Project	IEEE 802.16 Broadband Wireless Access Working Group < <a href="http://ieee802.org/16">http://ieee802.org/16</a> >	
Title	Subscriber Mode Management	
Date Submitted	2005-07-11	
Source(s)	Yun Won Chung, PhD Jee Hyeon Na, Sang Ho Lee, PhD ETRI, 161, Gajeong-dong, Yuseong-gu, Daejeon, 305-700, Korea	<a href="mailto:yun.chung@etri.re.kr">yun.chung@etri.re.kr</a> <a href="mailto:jhna@etri.re.kr">jhna@etri.re.kr</a> <a href="mailto:leesh@etri.re.kr">leesh@etri.re.kr</a> Voice: +82-42-860-5244 Fax: +82-42-861-1966
Re:	Call for Comment on P802.16g Baseline Document	
Abstract	This contribution proposes subscriber mode management.	
Purpose	The document should be considered during the resolution of comments on the baseline document.	
Notice	This document has been prepared to assist IEEE 802.16. It is offered as a basis for discussion and is not binding on the contributing individual(s) or organization(s). The material in this document is subject to change in form and content after further study. The contributor(s) reserve(s) the right to add, amend or withdraw material contained herein.

# Subscriber Mode Management

Fig. 3 - Subscriber Mode transition diagram at MSS and BS

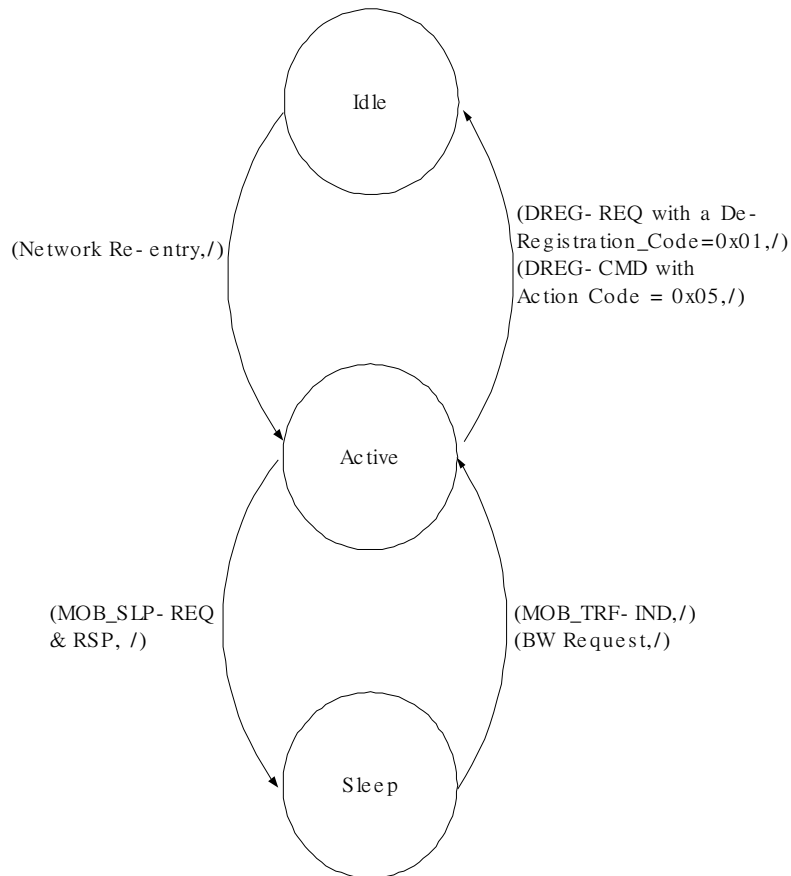
[Modify section 14.5.7 as follow]

Figure 3 shows Subscriber Mode transition diagram at both an MSS and a BS. Subscriber Mode at both an MSS and a BS changes from Active Mode to Idle Mode when the MSS issues an MSS De-registration Request (DREG-REQ) message with `De-Registration_Request_Code=0x01` or the BS issues a De-register Command (DREG-CMD) message with `Action Code = 0x05`. Then, the MSS stays at Idle Mode and updates its location when the paging group changes. The Subscriber Mode returns back to Active Mode from Idle Mode after completing Network re-entry. Transition from Active Mode to Sleep Mode is performed after an MSS successfully exchanges Sleep Request (MOB\_SLP-REQ) and Sleep Response (MOB\_SLP-RSP) messages with a BS. If there is any DL traffic toward an MSS from a BS, MOB\_TRF-IND is broadcast to the MSS from the BS and Subscriber Mode of the MSS and the BS changes from Sleep Mode to Active Mode. If there is any UL traffic from an MSS, Bandwidth Request (BW Request) is sent to the serving BS from the MSS and Subscriber Mode of the MSS and the BS changes from Sleep Mode to Active Mode, too.

Fig. 4 - Subscriber Mode transition diagram at NCMS

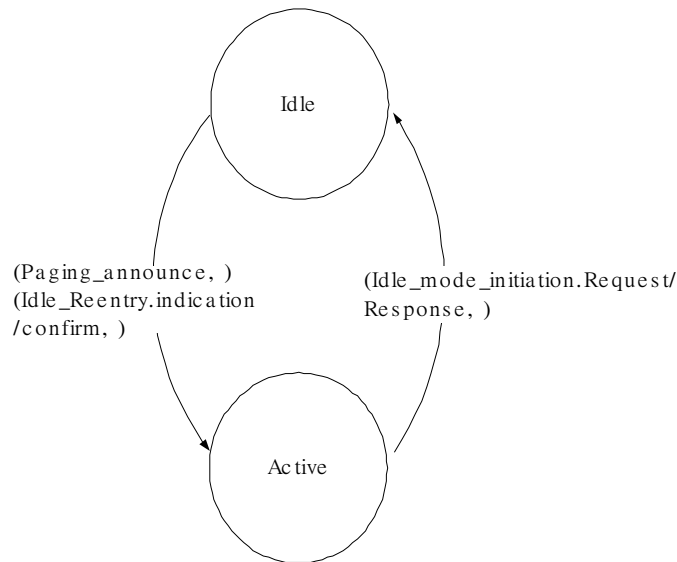
Figure 4 shows Subscriber Mode transition diagram at an NCMS with service primitives related with the Subscriber Mode transition. Subscriber Mode transition from Active Mode to Idle Mode is performed by exchanging `Idle_mode_initiation.request` and `Idle_mode_initiation.response` between a BS and an NCMS after successful DREG-REQ message with `De-Registration_Request_Code=0x01` or DREG-CMD message with `Action Code = 0x05` between an MSS and a BS, where `Idle_mode_initiation.request` and `Idle_mode_initiation.response` are defined in 14.5.11.1 and 14.5.11.2, respectively. Subscriber Mode transition from Idle Mode to Active Mode is initiated after exchanging `Paging_announce`, `Idle_ReEntry.indication`, and `Idle_ReEntry.confirmation` between a BS and an NCMS, where `Paging_announce`, `Idle_ReEntry.indication`, and `Idle_ReEntry.confirmation` are defined in 14.5.11.3, 14.5.11.4, and 14.5.11.5, respectively.
